RICHMOND SUBDIVISION, FOURTH ADDITION

APPLICATION NUMBER 15 DATE June 16, 2005

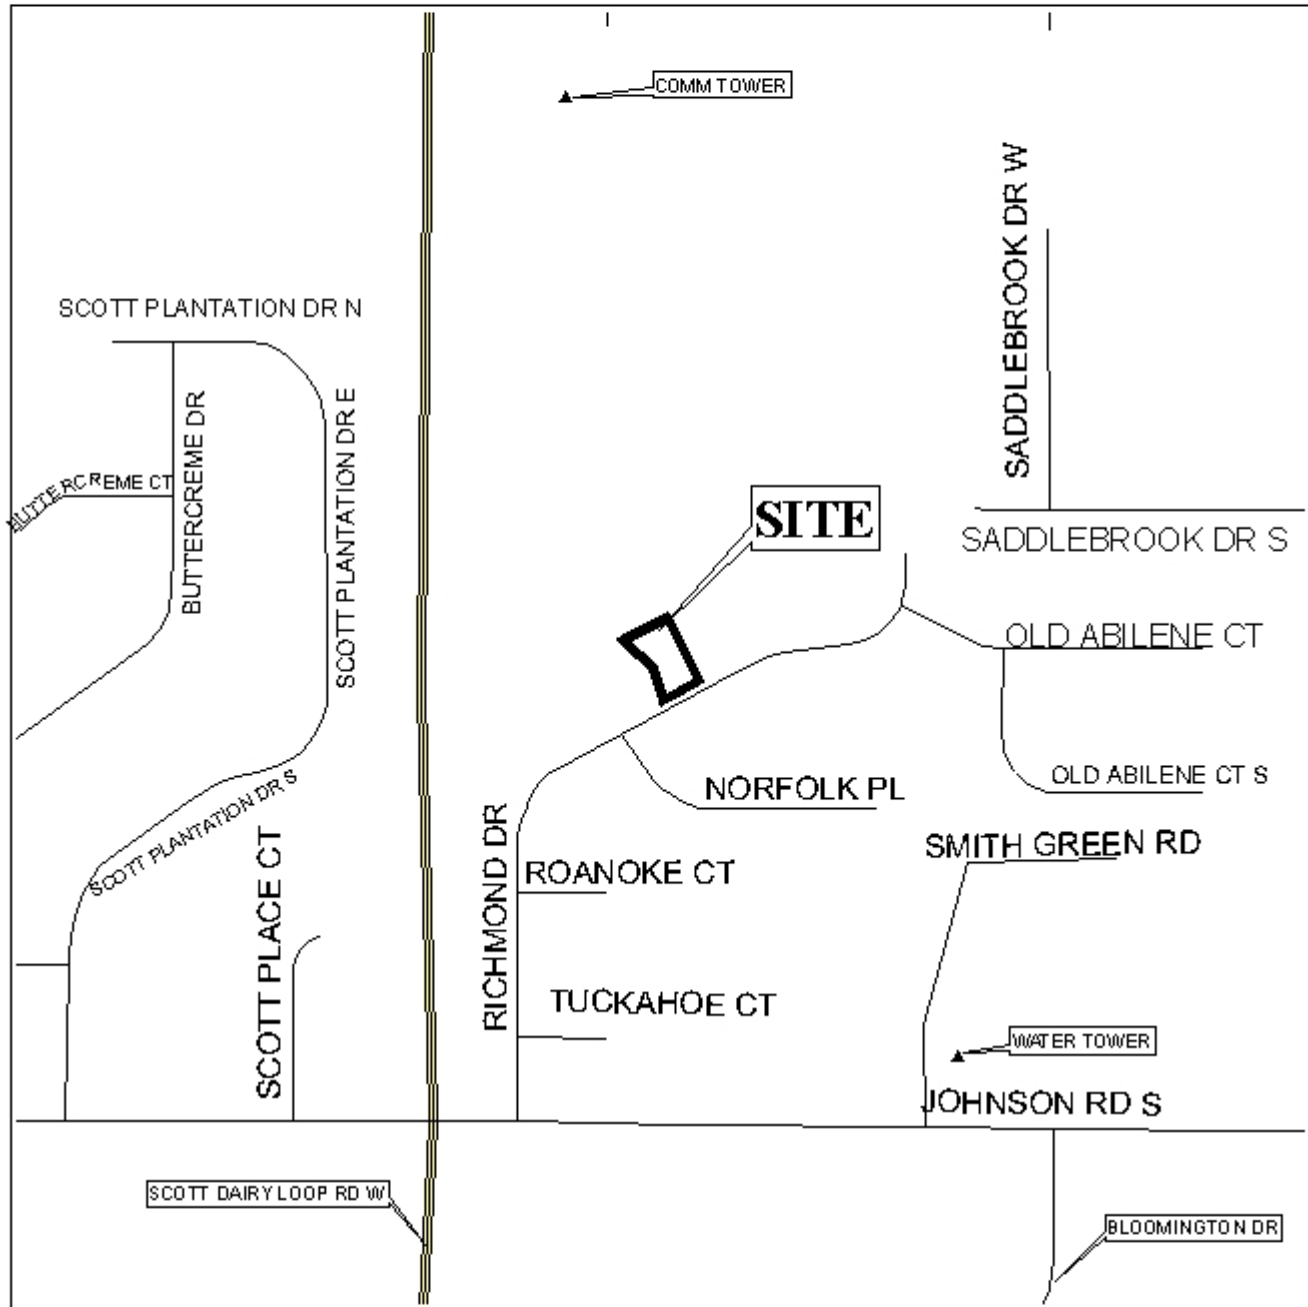
This site is located in the County, thus a note should be placed on the final plat stating that any lots which are developed commercially and adjoin residentially developed property must provide a buffer, in compliance with Section V.A.7. of the Subdivision Regulations.

The required 25-foot minimum building setback lines are not shown, but would be required on the final plat.

The plat meets the minimum requirements of the Subdivision Regulations and is recommended for Tentative Approval subject to the following conditions: 1) the placement of a note on the final plat stating that any property that is developed commercially and adjoins residentially developed property shall provide a buffer, in compliance with Section V.A.7. of the Subdivision Regulations; and 2) the placement of the 25-foot minimum building setback lines on the final plat.
